Newcastle Inner City Bypass
Rankin Park to Jesmond

**Newcastle Inner City Bypass –
Rankin Park to Jesmond
Submissions and preferred
infrastructure report**

June 2018

Figure 5-8c
 Construction ancillary facilities

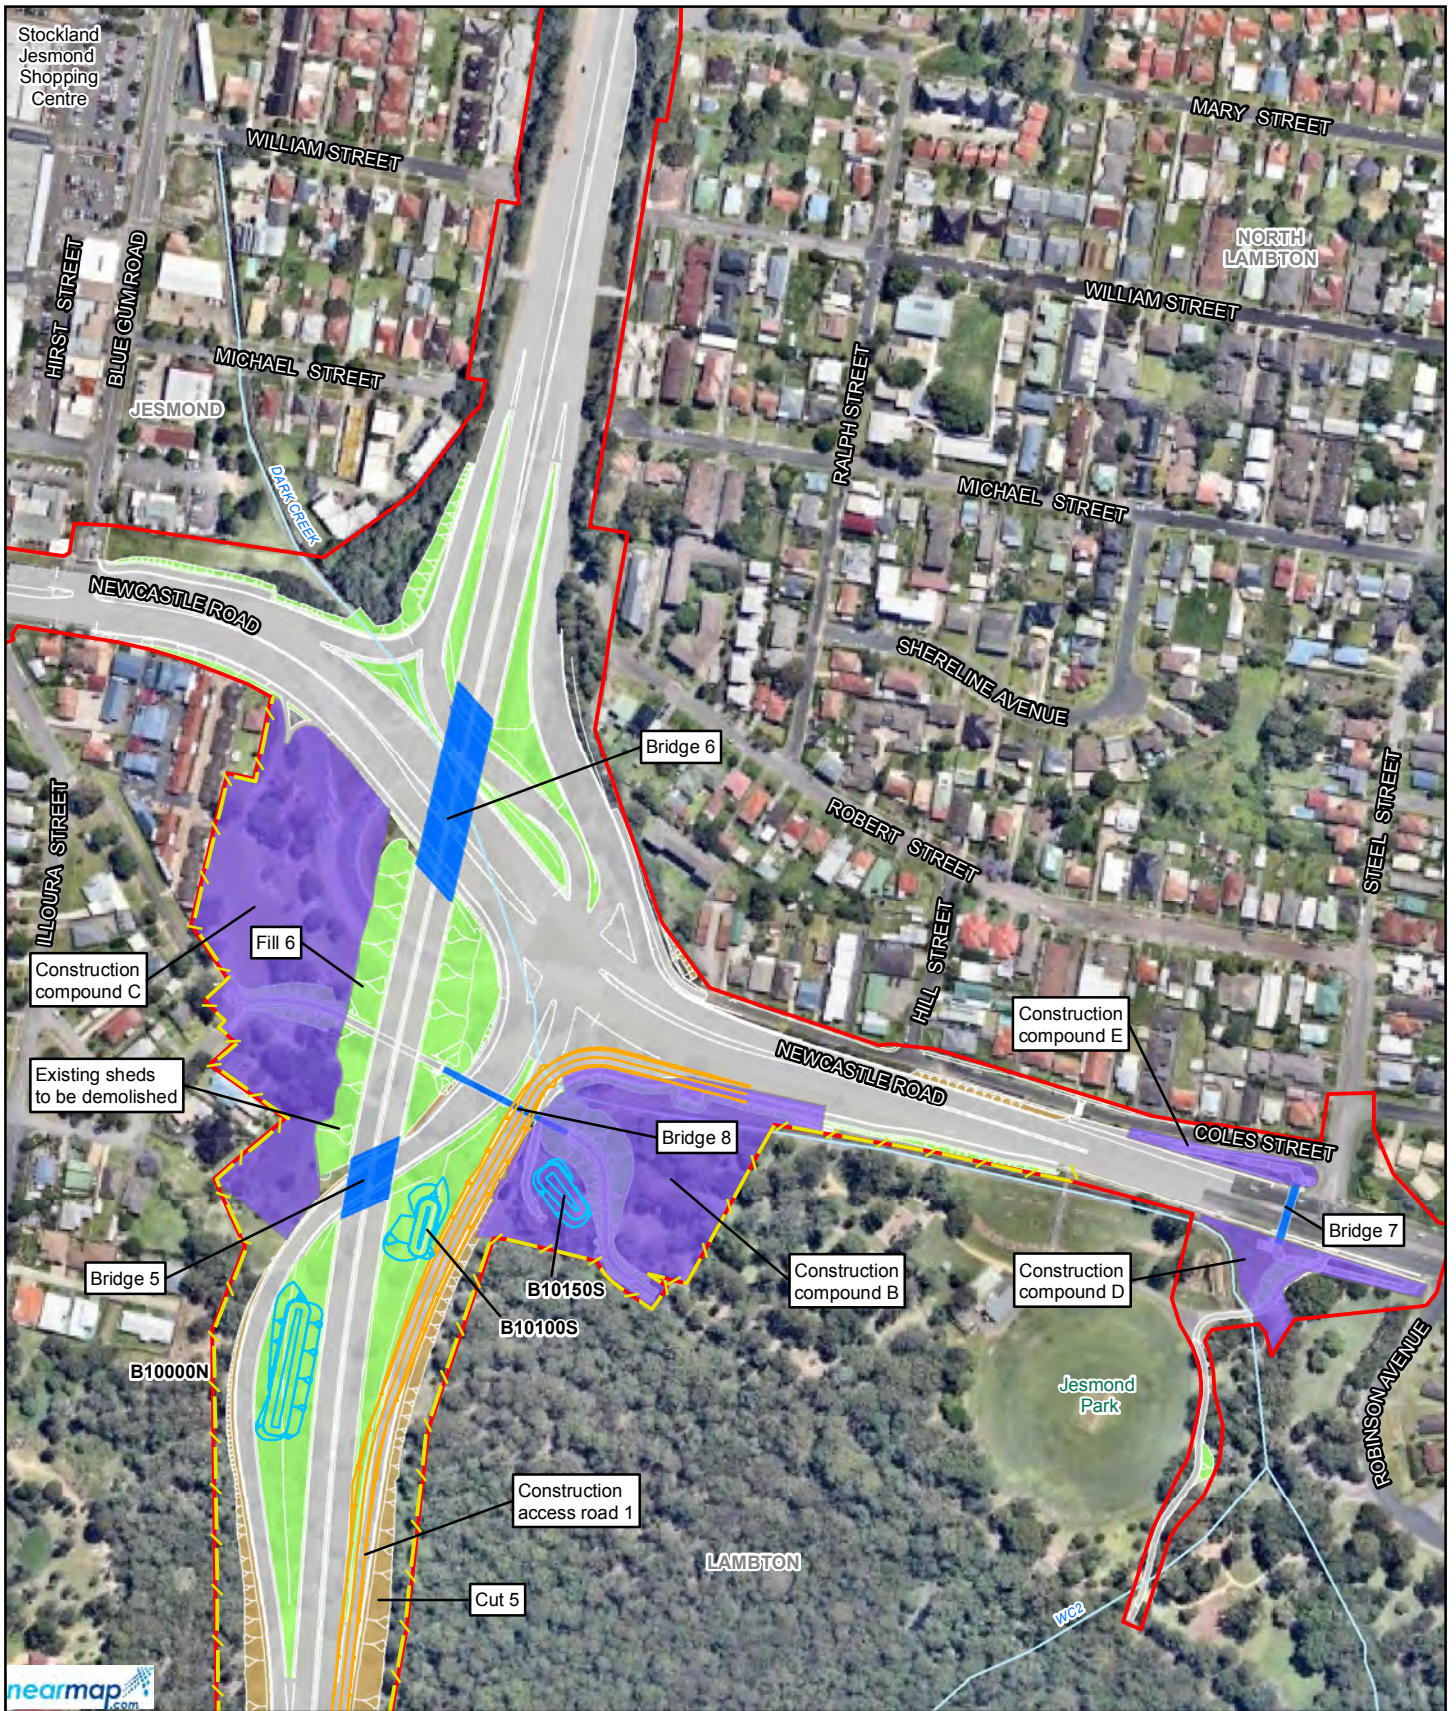
The locations of the construction compounds are shown in Figure 5-8 and a description is provided in the following sections. They have been located based on:

Compound D (new compound) is about 0.2 hectares in area and is located near the eastern end of Jesmond Park on the southern side of Newcastle Road (Figure 5-8). Access to this construction compound would be via Robinson Avenue and/or temporary access arrangement from Newcastle Road.

Compound E (new compound) is about 0.1 hectares in area and is located near the intersection of Coles Street and Steel Street on the northern side of Newcastle Road (Figure 5-8). Access to this construction compound would be via Steel Street, Coles Street and/or temporary access arrangement from Newcastle Road.

Compound F (new compound) is about 0.9 hectares in area and is located near the southern interchange on the western side of Lookout Road (Figure 5-8). Access to this construction compound would be via Lookout Road and/or McCaffrey Drive.

Due to other design refinements, during construction there will be still be about 16 sedimentation basins but some would be in new locations to capture sediment laden runoff from construction areas (Figure 5-8).

Figure 5-9
Bridge 2

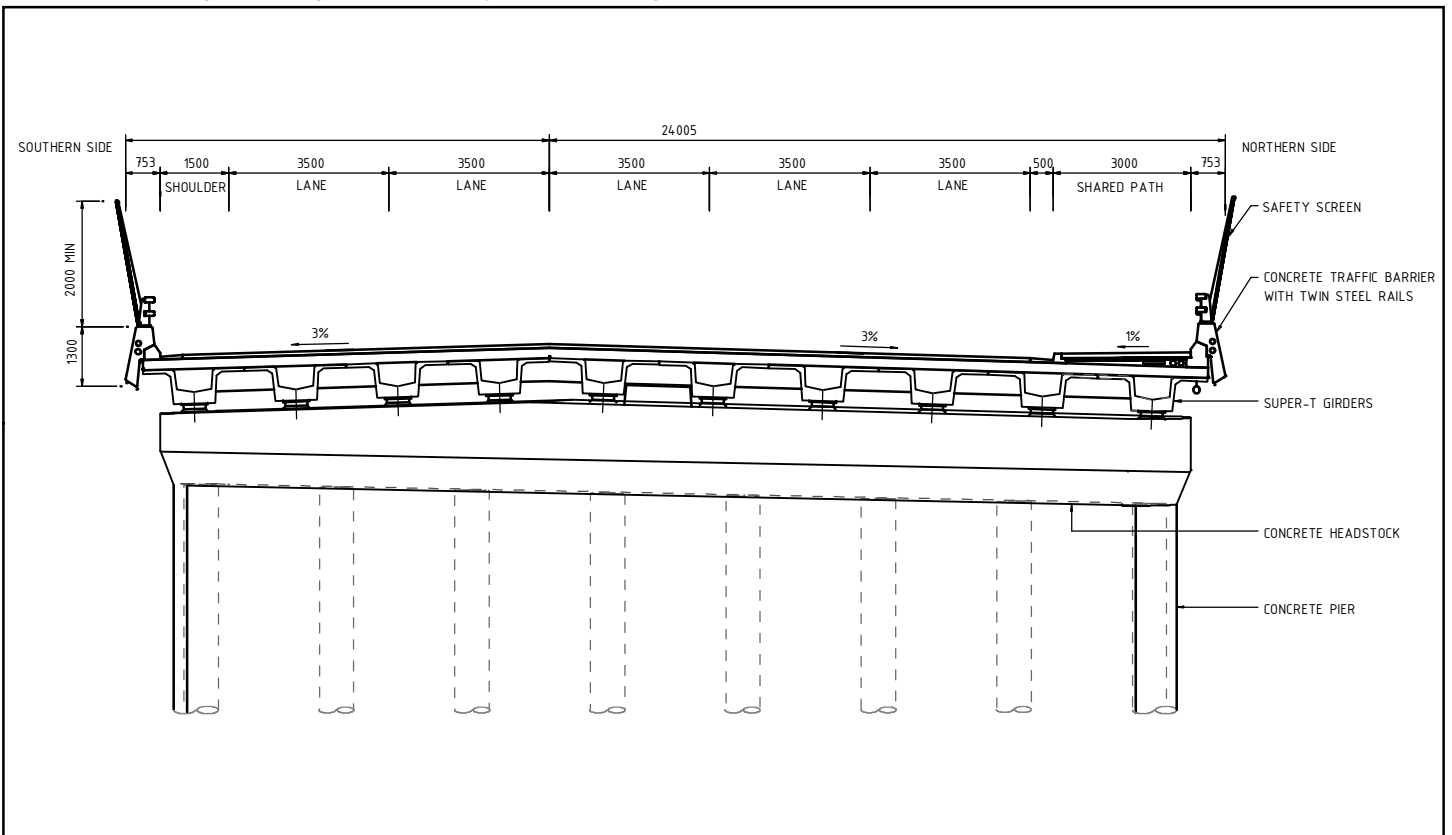
The refined design for Bridge 2 is shown in Figure 5-9.

Figure 5-10
Bridge 3

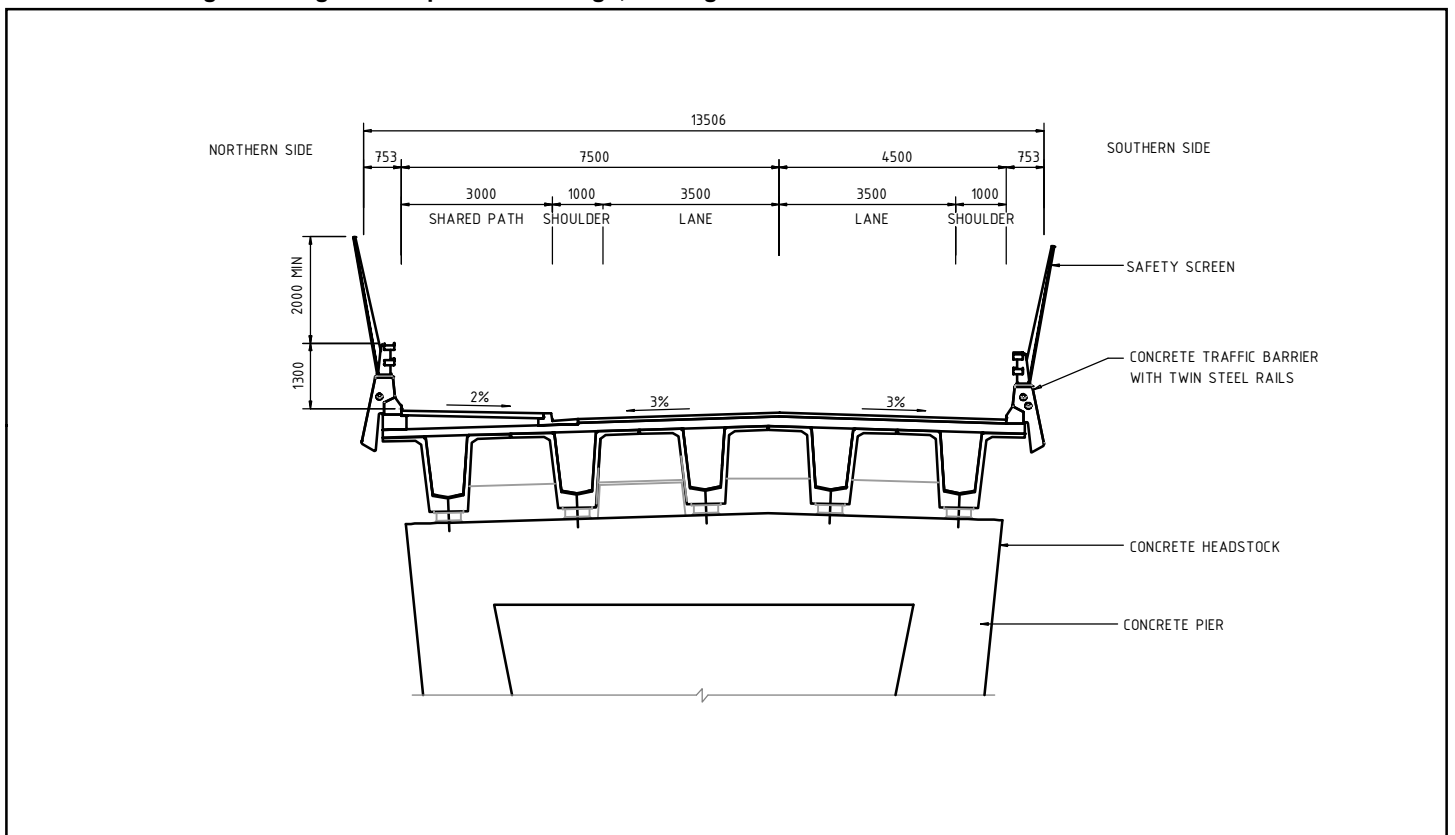
The refined design for Bridge 3 is shown in Figure 5-10.
